Approaches to demonstrating compliance with the dose criteria in 10 CFR 20.1402 approved in Hematite's decommissioning plan

NRC Summary of Approaches Approved in Hematite's DP

Procedure HDP-PR-FSS-721

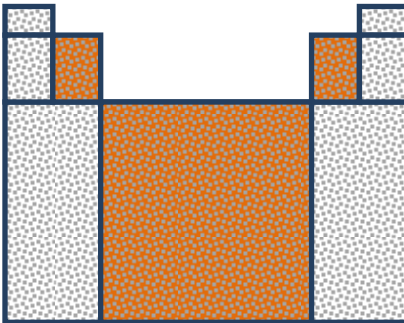
Approach	Westinghouse Reference	NRC Comments
	HDP-PR-FSS-721	<ul style="list-style-type: none"> Step 8.4.5 C of HDP-PR-FSS-721 implies that the approach shown in the above picture can be used This approach is inconsistent with Westinghouse's DP and the conclusions in NRC's SER and is unacceptable

- (1) Correct the procedure (HDP-PR-FSS-721) to be consistent with the DP (i.e., modify the procedure to prohibit the combining of the uniform and three layer approaches in any given vertical column). The presence of contamination in multiple layers should be accounted for using one of the previously approved approaches described above.

- (2) Alternatively, provide the NRC with a revised approach for demonstrating compliance with the dose criteria in 10 CFR 20.1402. Note that any changes to the DCGLs would require a license amendment.

Conceptual Site Models (CSMs) used by Westinghouse in development of DCGL values in the Hematite Decommissioning Plan (Fig 5-4 in the decommissioning plan [DP]):

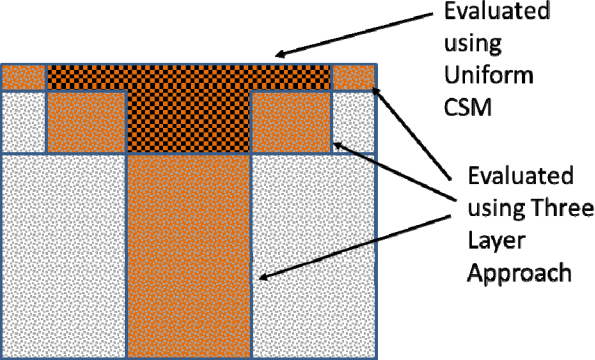
- Two subsurface geometries were considered in the DP (Section 5.3.3.1):
 - a soil column comprised of surface, root, and deep layers,
 - one stratum with uniform contamination.

- DCGL values equivalent to 25 mrem/yr were derived by Westinghouse for each radionuclide for each CSM assuming the soil in other layers was clean.
- Because of the manner in which the DCGLs were derived in the three layer approach (i.e., surface, root, deep CSMs), soil being at the DCGL in each layer would lead to a dose of >25 mrem/yr. A sum of fractions approach must be used to account for contamination in multiple layers.

- NRC's Dose Assessment Conclusions in safety evaluation report (SER) for the DP:
 - "The use of the alternative CSMs is appropriate as long as each area is determined to fall under either the Surface, Root, Deep CSM (applying the sum of fractions rule as appropriate), or the Uniform model."
